Agenda – Executive Policy Committee – December 5, 2018

Item No. 6 Subdivision and Rezoning – 1493 Magnus Avenue (Point Douglas Ward) File DASZ 9/2018 [c/r DAV 125313/2018D]

Title: DASZ 9/2018 – 1493 Magnus Ave

SUBJECT: To rezone the subject property to an "RMF-S" Residential Multi-Family (Small) zoning district for the purposes of constructing a townhouse development

Schedule "A" for File No. DASZ 9/2018, Lord Selkirk – West KIldonan Community Committee, dated May 8, 2018

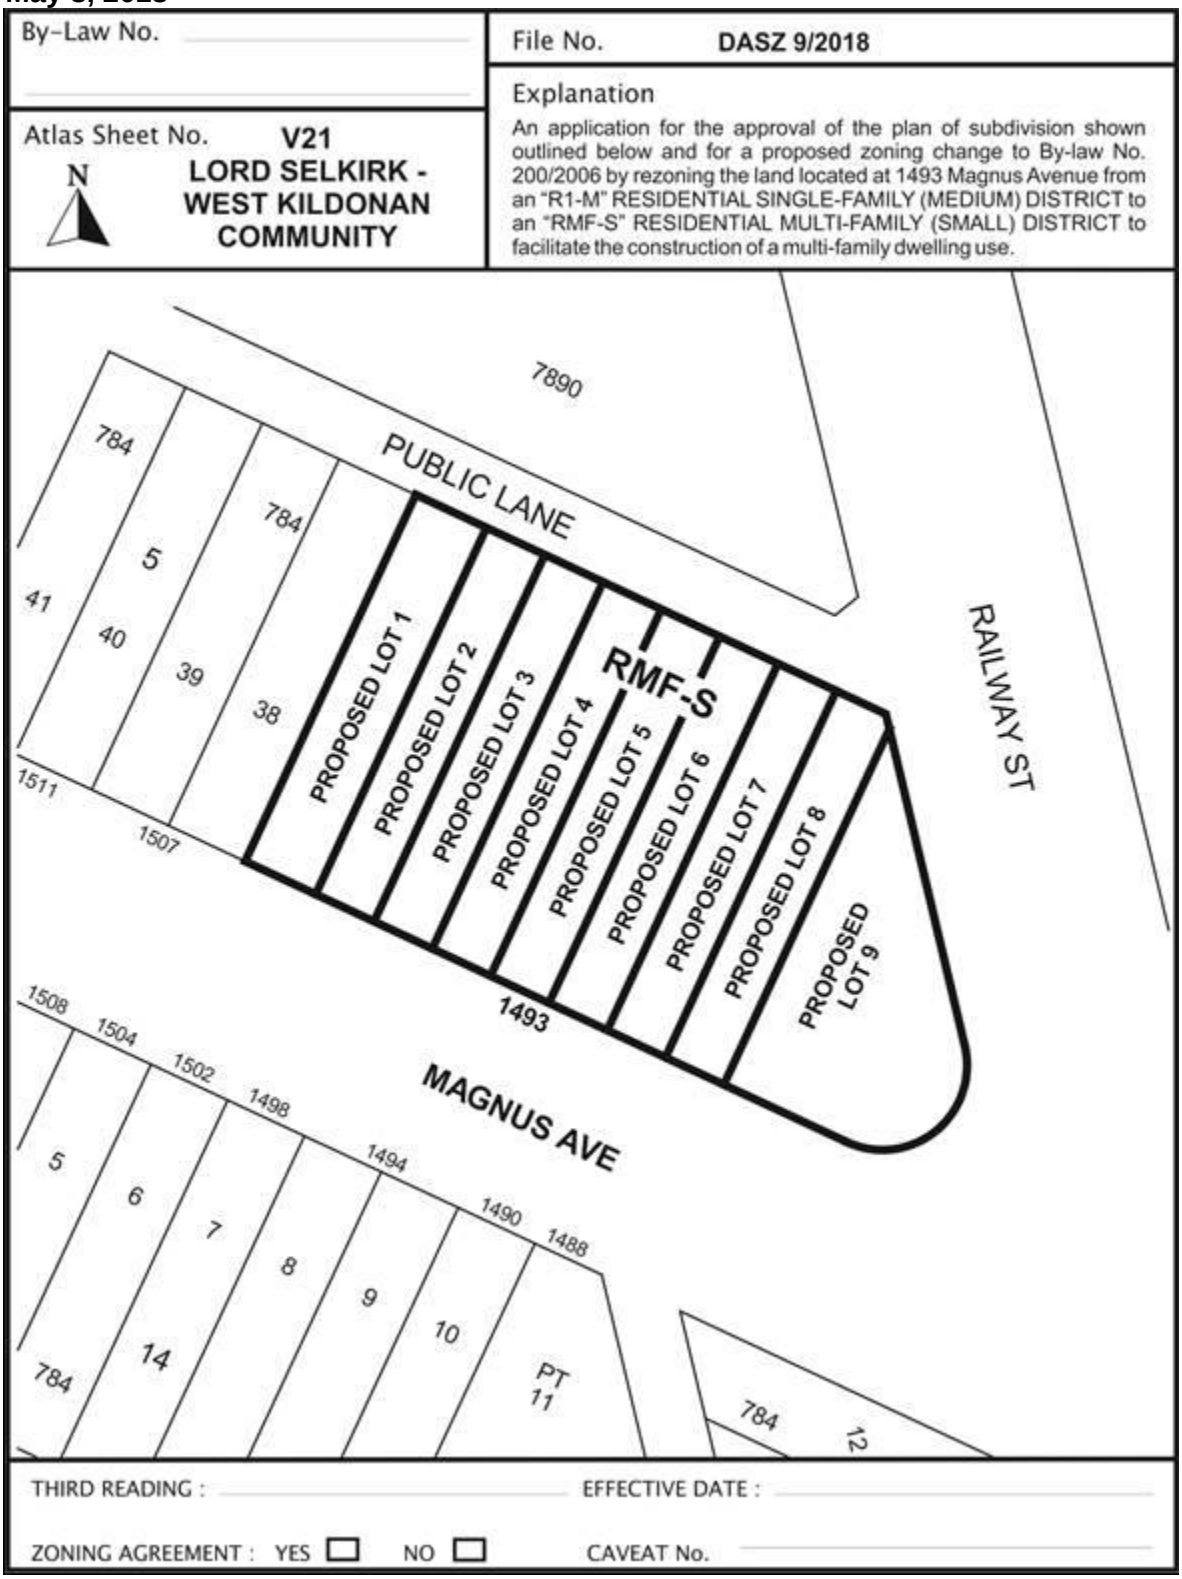
- However, there are aspects of the design of the proposed use that are inconsistent and incompatible with the existing character of the neighbourhood. Specifically, the site plan illustrates a private approach gaining access to proposed unit #9 from Magnus Ave. Given that the property is served by a public lane, the expectation is that all vehicular access to the site must be from the public lane. The Public Service believes there are alternatives to the design of the site to avoid the need for any approaches onto existing streets abutting the site. The length of the lane providing direct access to the subject site is approximately 150 feet which provides ample opportunity for site access.

- Given this situation, the Public Service recommends that proposed Lot 9 be amalgamated with Proposed Lot 8 to alleviate site access issues. To this end, a new Schedule (Schedule “D”) has been created and appended to this report and it is recommended it replace Schedule “A, the subdivision plan submitted by the applicant.

- As noted previously in this report, the proposed private approach on Magnus Ave is not supported. Therefore, while the Public Service recommends approval of the zoning designation to allow multi-family development, the applicant will be expected to revise the site plan to remove the approach and take access from the existing public lane.

Exhibit “8” referred to in File DASZ 9/2018

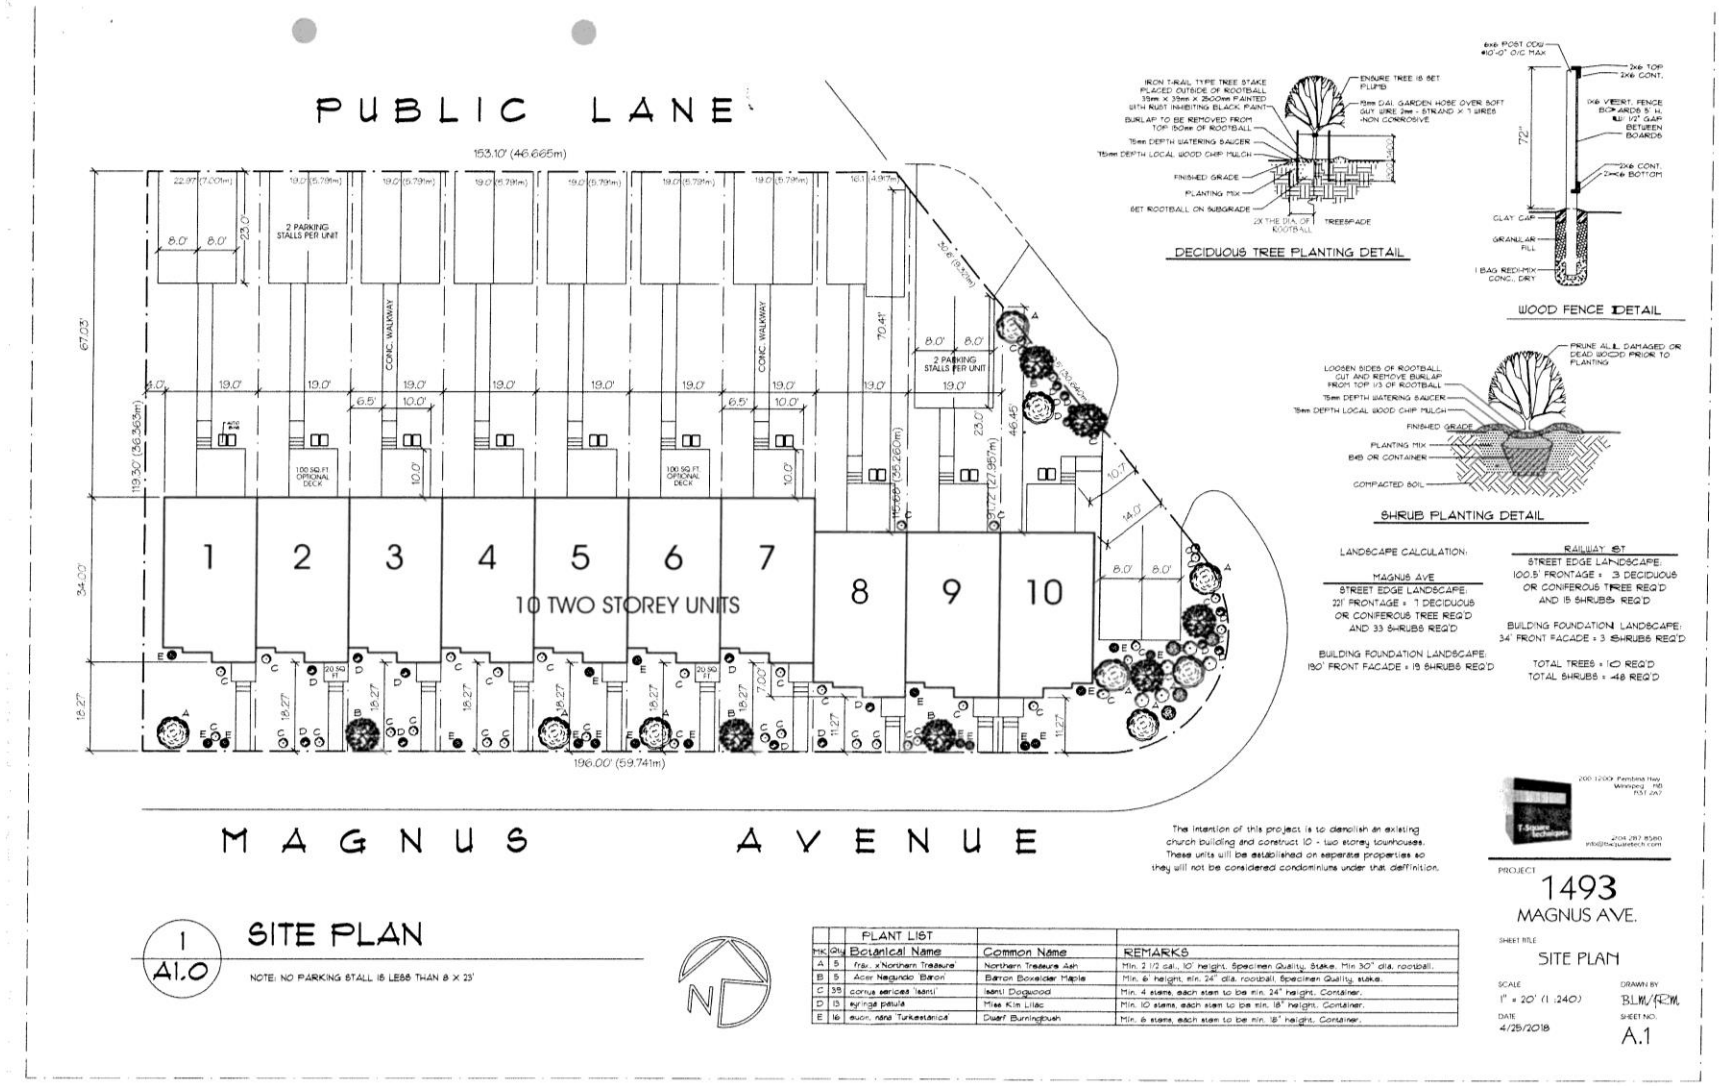
- *Reduced berm heights are possible where larger setbacks are proposed.*
- It is noted that the proponent's site plan does not adhere to the above standards. The applicant is aware of the concerns of the Public Service and Council direction, but wishes not to construct the berm. Instead of rejecting the application altogether, the Urban Planning Division is recommending the above requirements be stated in recommended zoning agreement for this application.

- The Division believes the site plan can be modified in a number of ways to meet the *Federation of Canadian Municipalities "best practices"*. For example, if the proposed unit on Lot 8 remains in the same place under the recommended approval of Schedule 'D', the required berm on Proposed Lot 8 could easily be accommodated within the site due to the increased setback of the dwelling from the CPR Arborg Subdivision.

- Per recommended condition 2.A.(ii)(d) of the zoning agreement, the berm height can be reduced if the setback is increased. The subject site is separated from the CPR Arborg Subdivision by Railway Street (which is +/-65 feet wide), and the site plans submitted show that the dwelling on Lot 8 is approximately 45 feet from the eastern property line.

- *Dwellings are to be setback 15 metres (49.2 feet) from a branch line right-of-way;*
    - *A two metre (6.6 foot) high berm, with a side slope no more than a rise of one and a run of 2.5, is to be built alongside the rail line right-of-way;*
